Drainage Management Plan

Z-Coil

CONCEPTUAL GRADING & DRAINAGE PLAN
1" = 30'

PROJECT NO. 040092
DATE 4-15-03

PROPOSED DRAINAGE PLAN

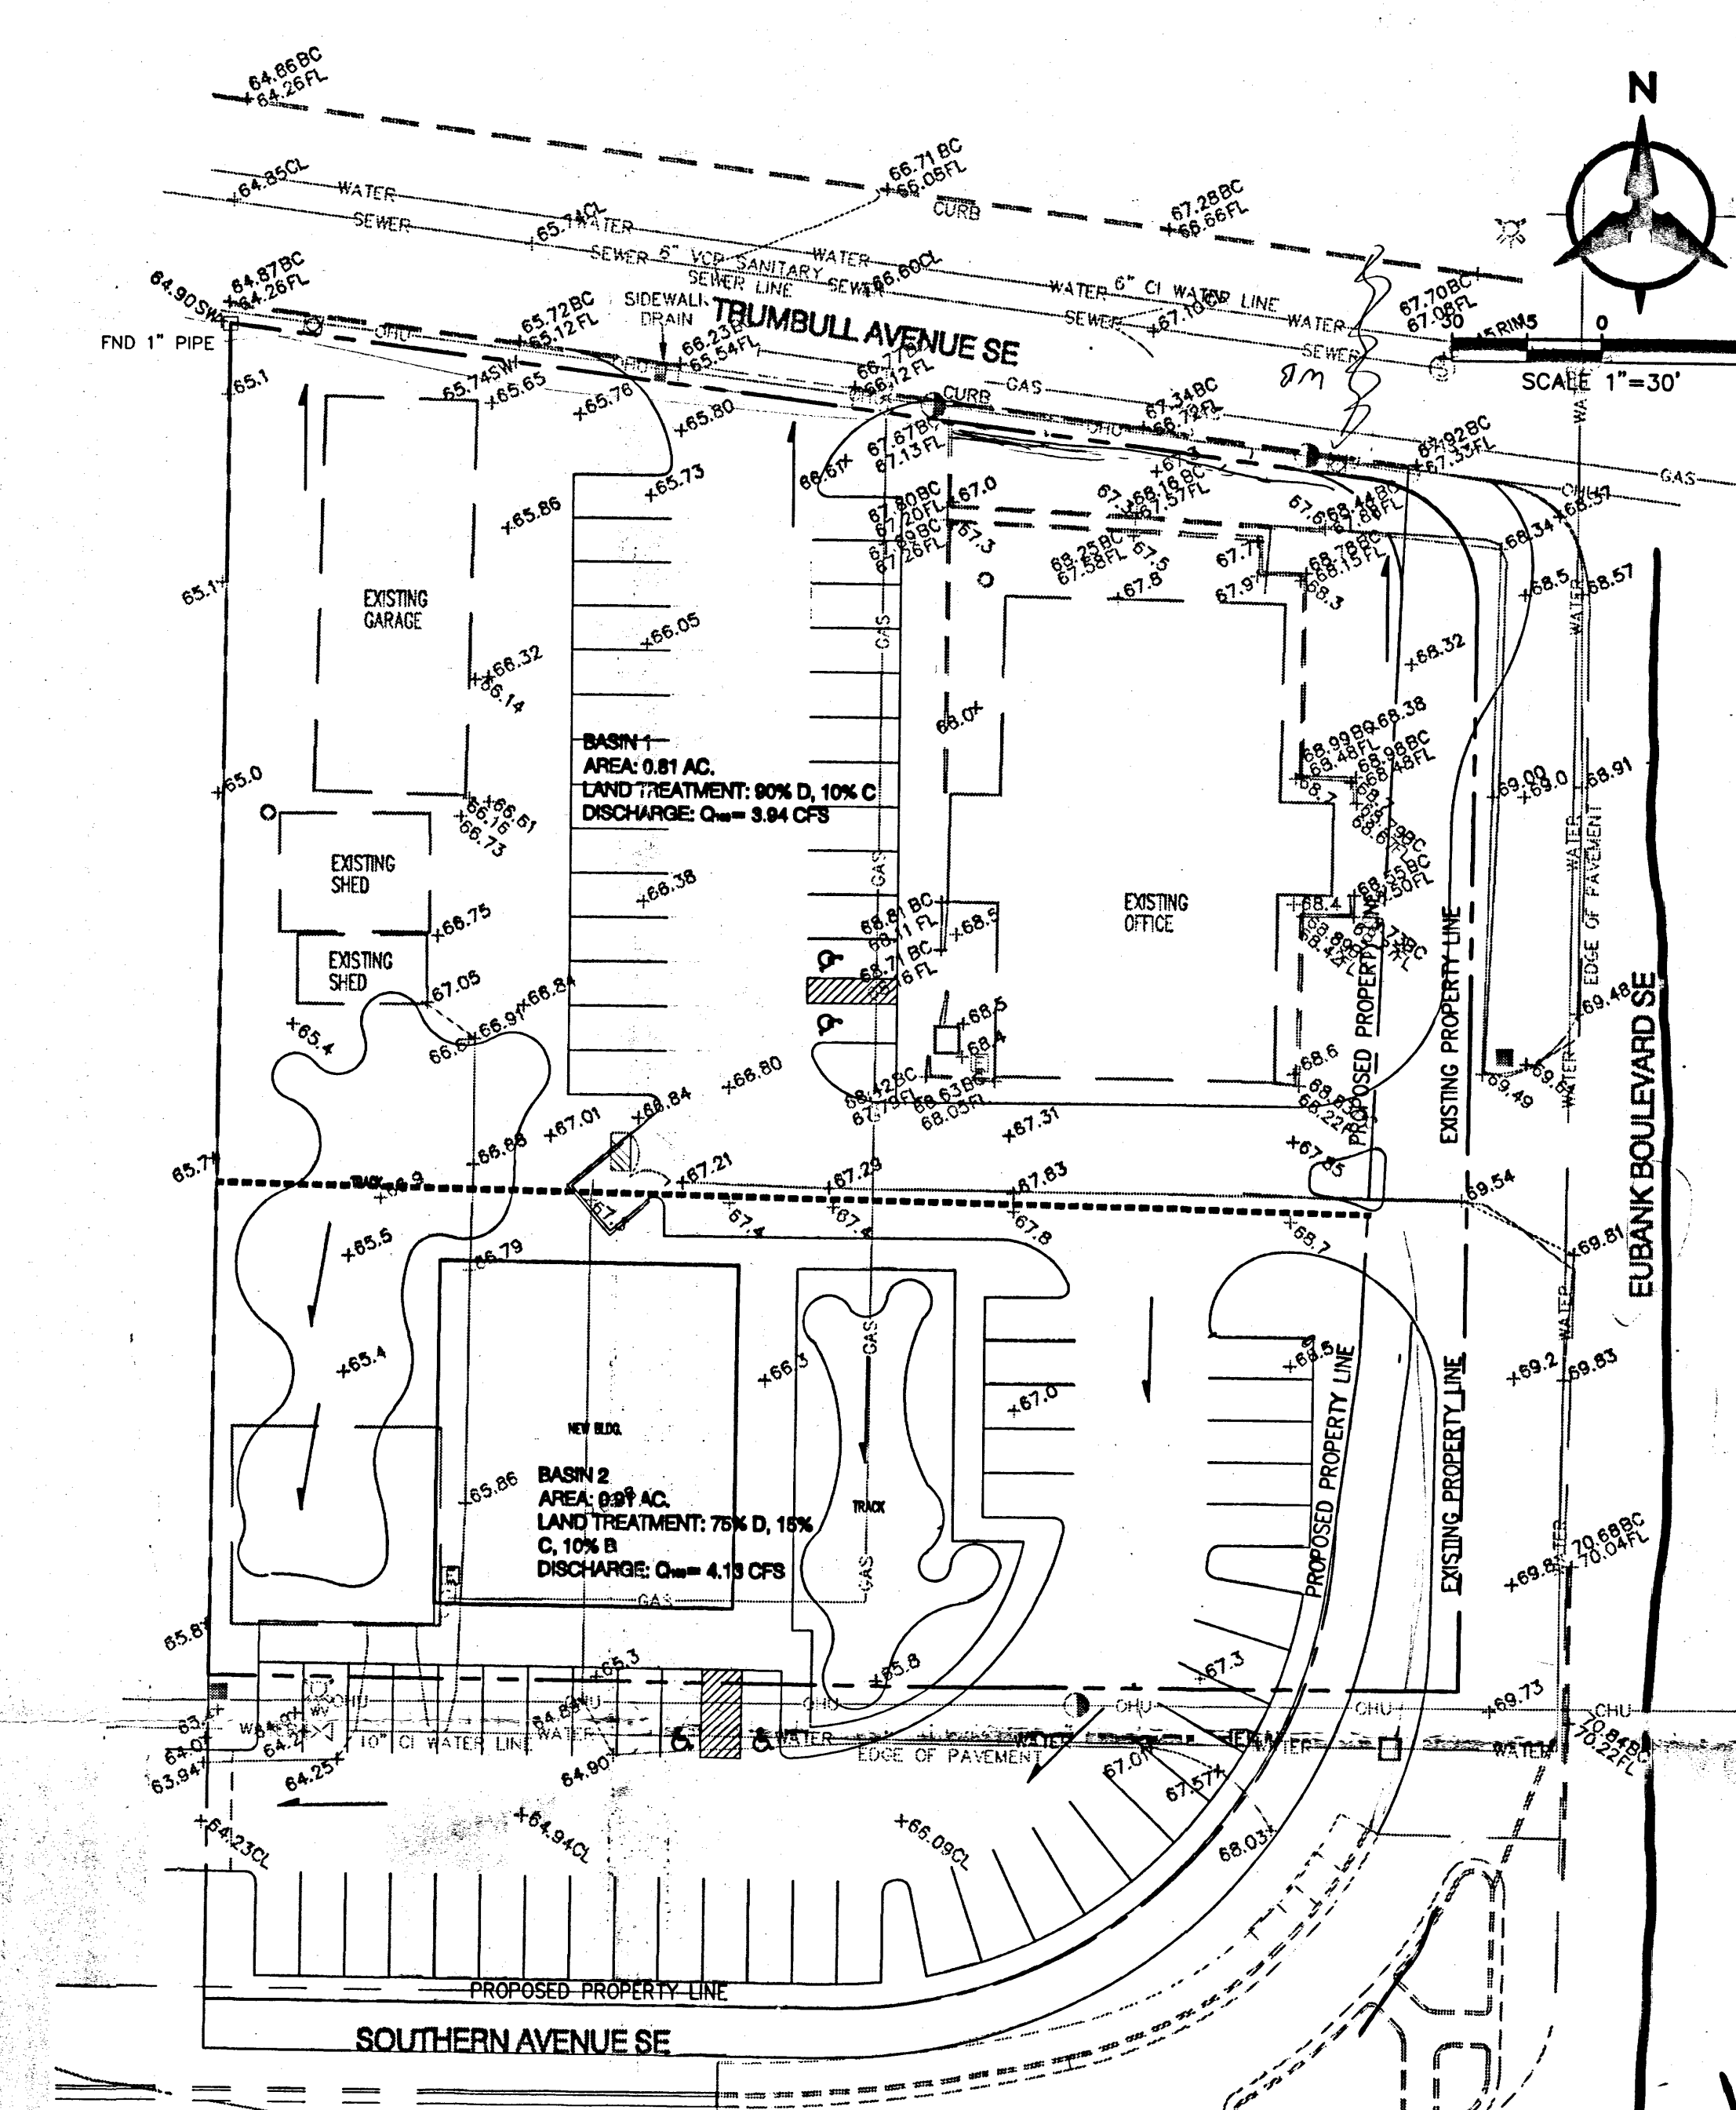
Show Eubank Storm Drain
